# WILLIAMSON COUNTY, TEXAS

CHANGE ORDER NUMBER: 21

Project Name: FM 3349 at US 79

**CO#21 - ESSI MBGF LOW FILL & LONG SPAN**

Design Division Standard	
<b>METAL BEAM GUARD FENCE (LONG SPAN)</b>			
<b>GF (31) LS-17</b>			
FILE: gf31ls17.dgn © TxDOT: December 2011 Revised 12, 2017 CL	Dwn TxDOT CONT SECT DIST	Ckn KM JOB COUNTY	Dwn VP HIGHWAY SHEET NO.

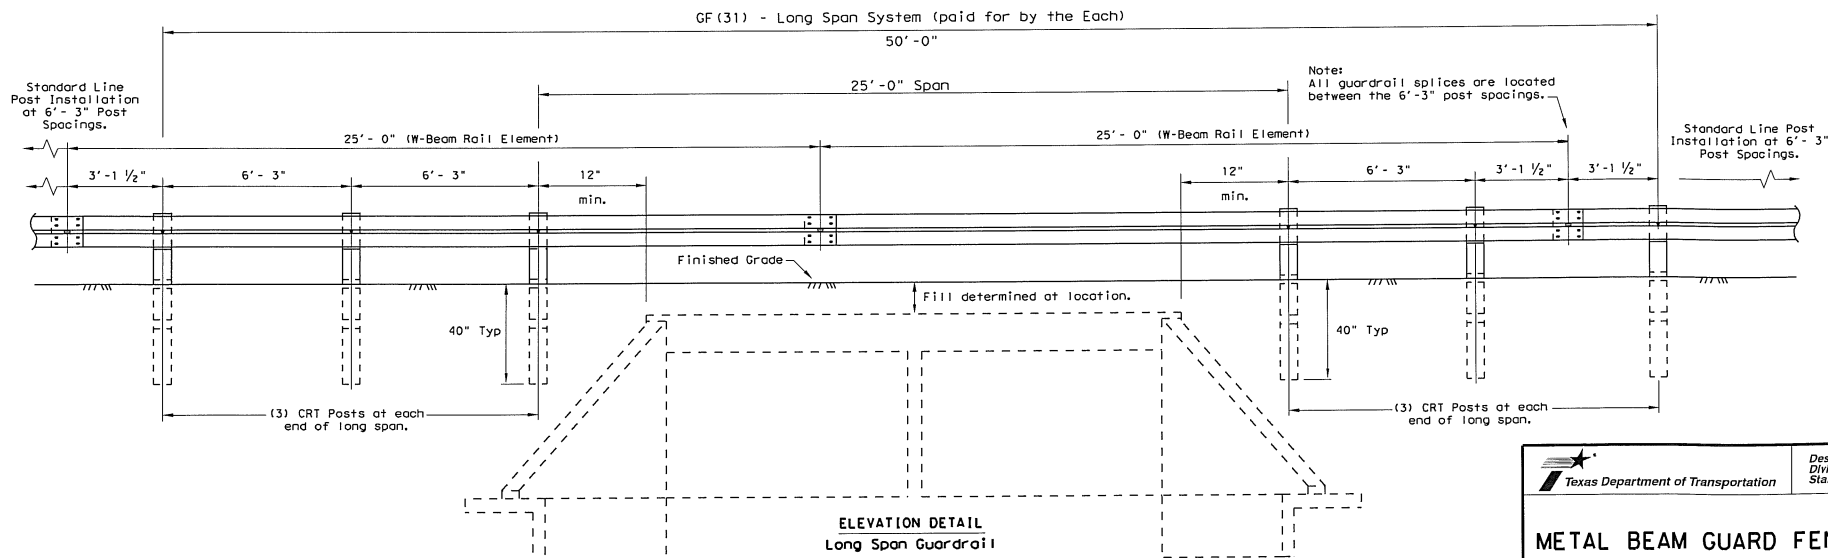
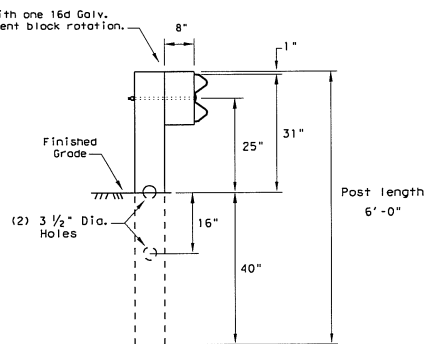
**1B. Design Error or Omission.** This Change Order compensates the Contractor for installing long-span metal beam guard fence in the project. At several locations on south bound frontage road (SBFR), the backless concrete inlets conflict with the location of the wooden posts supporting the metal beam guard fence (MBGF) runs. These conflicts were reviewed by the Engineer of Record, and it was recommended to utilize the TxDOT standard long-span MBGF to clear the conflicts. This solution has been agreed to by TxDOT Georgetown Area Office.

New or revised plan sheet(s) are attached and numbered: 194, 195 and GF (31) LS - 17

This Change Order compensates the Contractor for installing long-span metal beam guard fence in the project. At several locations on south bound frontage road (SBFR), the backless concrete inlets conflict with the location of the wooden posts supporting the metal beam guard fence (MBGF) runs. These conflicts were reviewed by the Engineer of Record, and it was recommended to utilize the TxDOT standard long-span MBGF to clear the conflicts. This solution has been agreed to by TxDOT.

ITEM	DESCRIPTION	QTY	UNIT
540 6017	MTL W-BEAM GD FEN (Long Span System)	100	LF
540 6020	MTL BM W- Beam GD Fence (Low Fill Culvert)	50	LF
